Notice of Decision

Site Plan Review & Floodplain Development Review

Sunset Village Apartments

SP-15-18/FP-03-18

**TITLE SHEET
AND SITE PLAN**

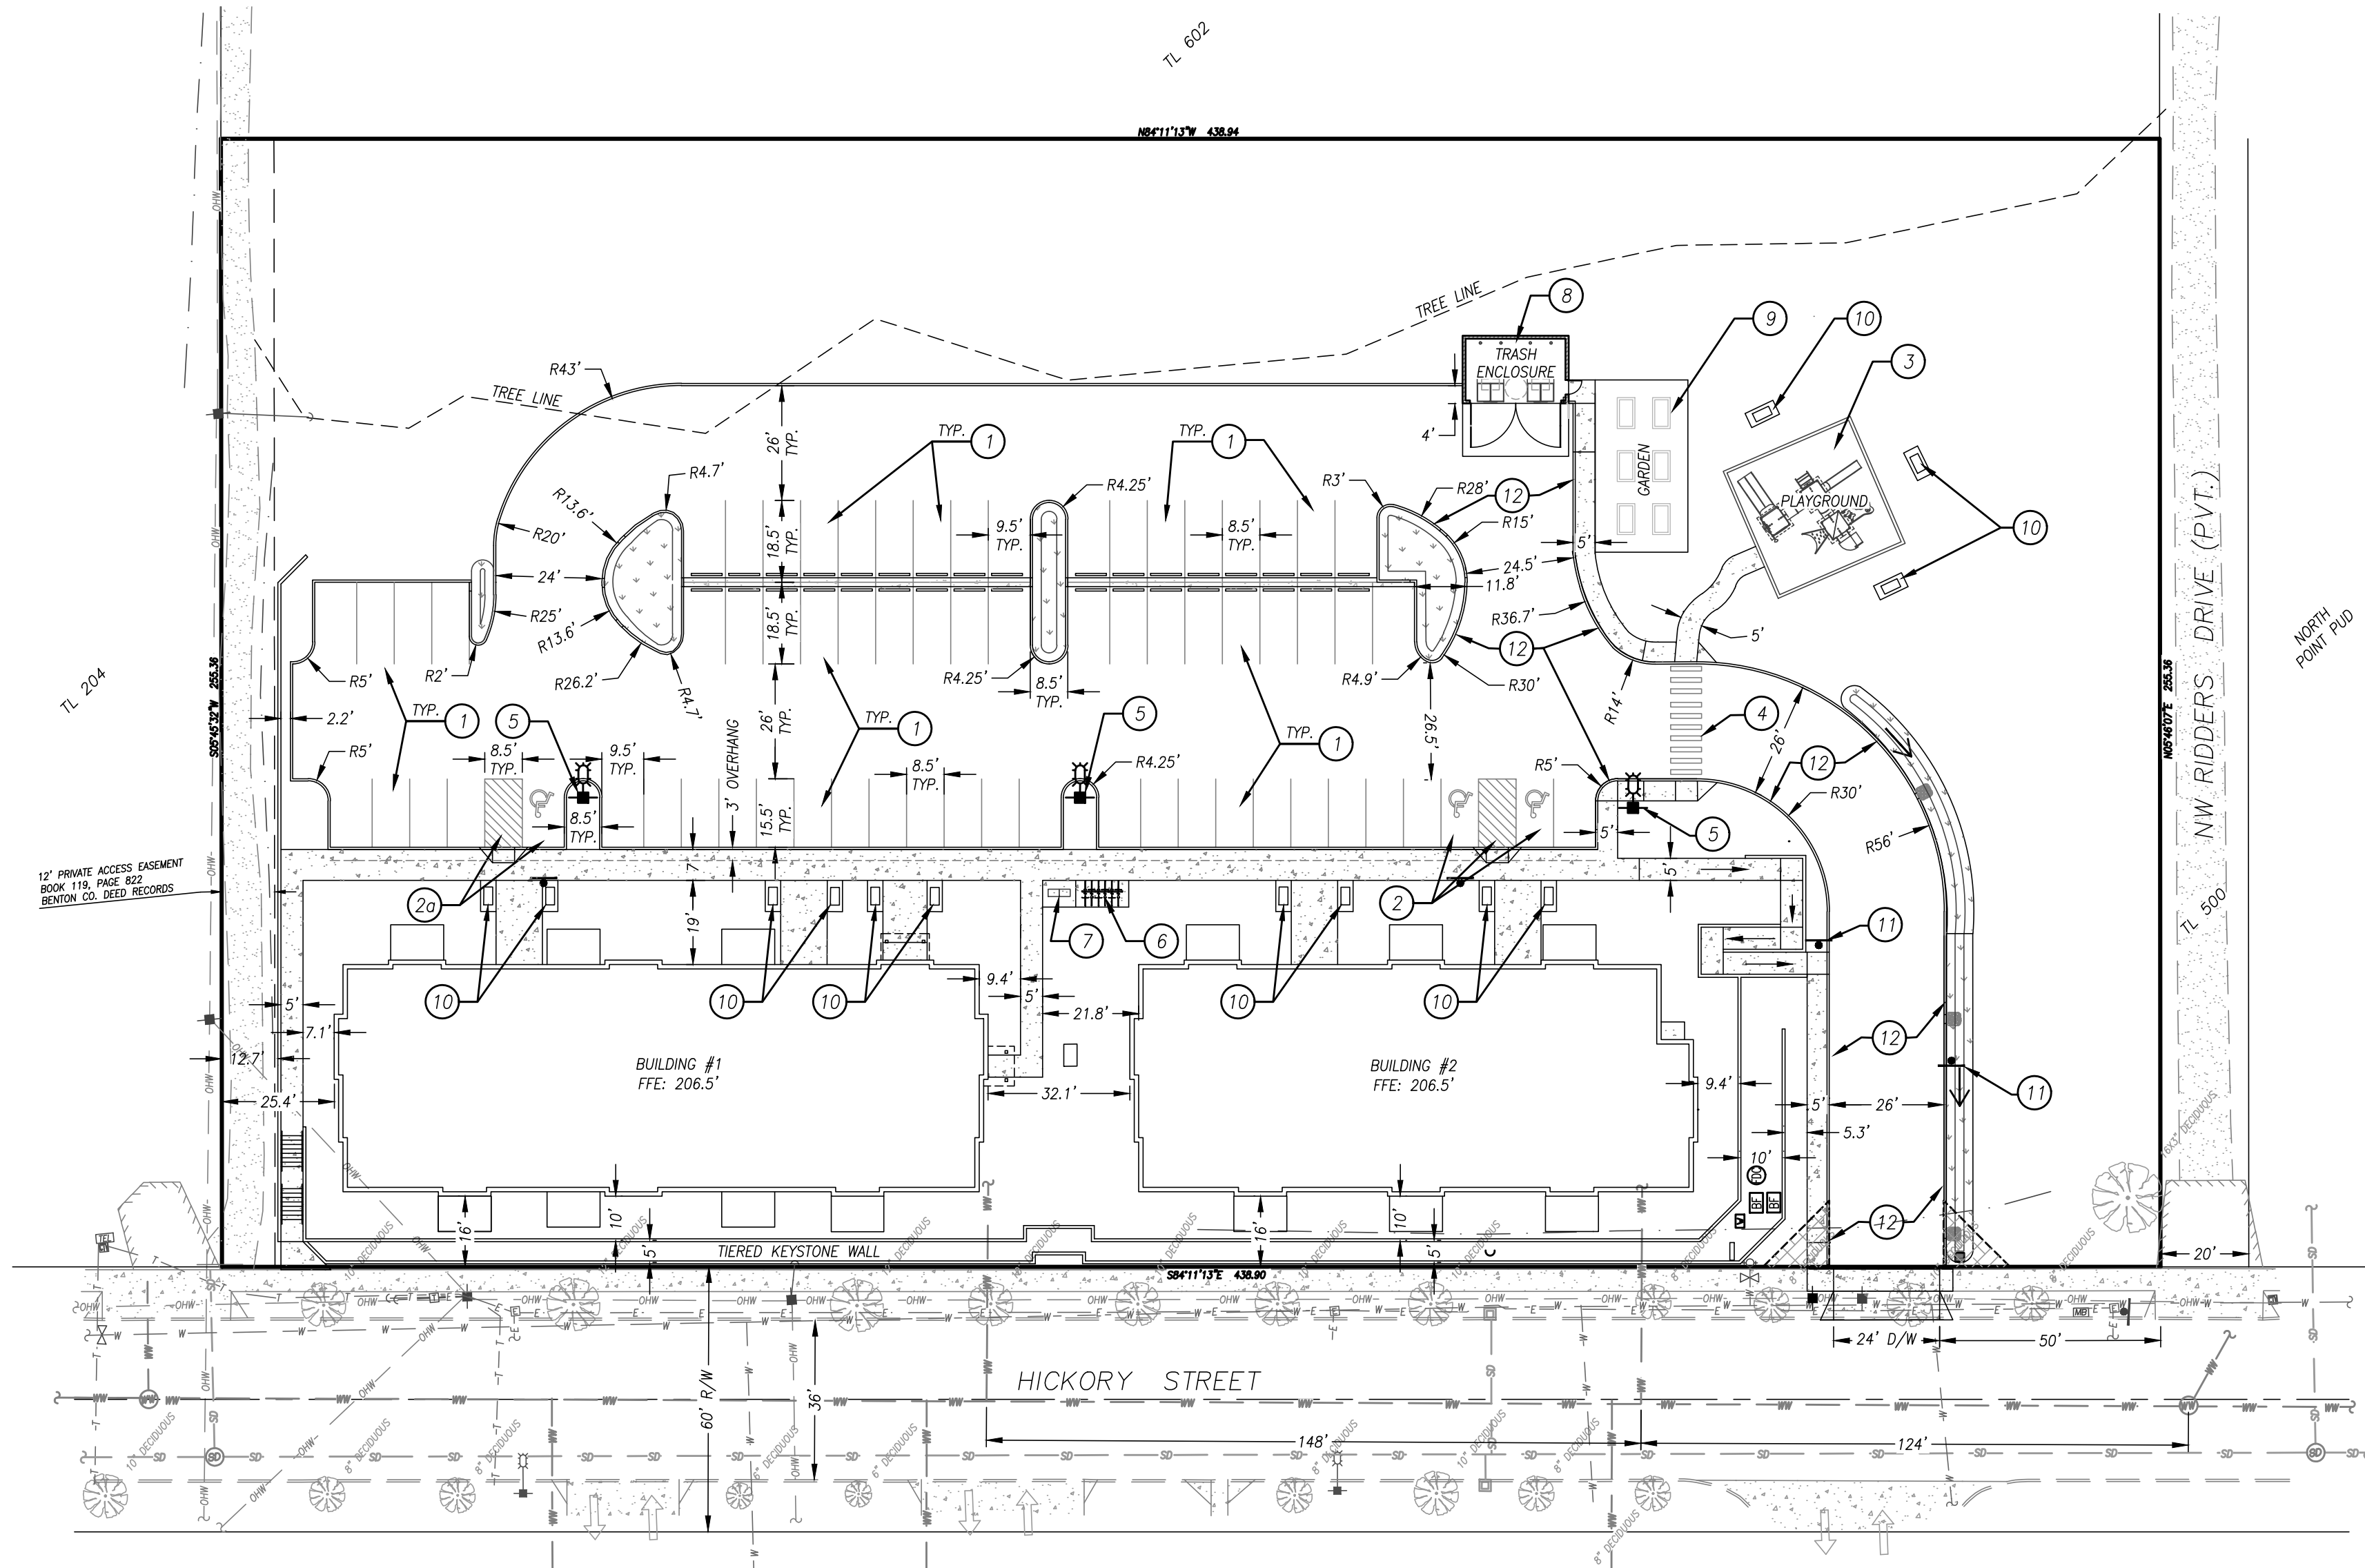
- Condition 3 Wheel Bumper/Sidewalk Width.** Prior to issuance of a building permit, the applicant shall submit a revised site plan to the Community Development Department for review and approval of the wheel bumper or sidewalk width requirement of ADC 9.120(6) and parking stall design standards of ADC 9.130. Table 9-2. Prior to issuance of a Certificate of Occupancy, all required secured wheel bumpers or 7.5' wide sidewalks shall be installed in compliance with the standards in ADC 9.120(6) and parking stall design standards of ADC 9.130. Table 9-2.

- Condition 5 Bicycle Parking.** Prior to issuance of a building permit, the applicant shall submit detailed plans to the Community Development Department for review and approval of the bicycle parking demonstrating how it meets the minimum parking space requirements of ADC 9.120(13)(a) and design standards of ADC 9.120(13)(e-h). Prior to issuance of a Certificate of Occupancy, all required bicycle parking spaces shall be installed in compliance with the standards in ADC 9.120(13)(e-h).

- Condition 9 At-Grade Patio Dimensions.** Prior to issuance of a building permit, the applicant shall submit revised first floor plans to the Community Development Department for review and approval that show at-grade patios meeting both the minimum size and dimensions standards of ADC 8.230(1).

Condition 10 Patio Screening. Prior to issuance of a building permit, the applicant shall submit a revised landscaping plan to the Community Development Department for review and approval that shows details of the screening from Hickory Street for the at-grade patios.
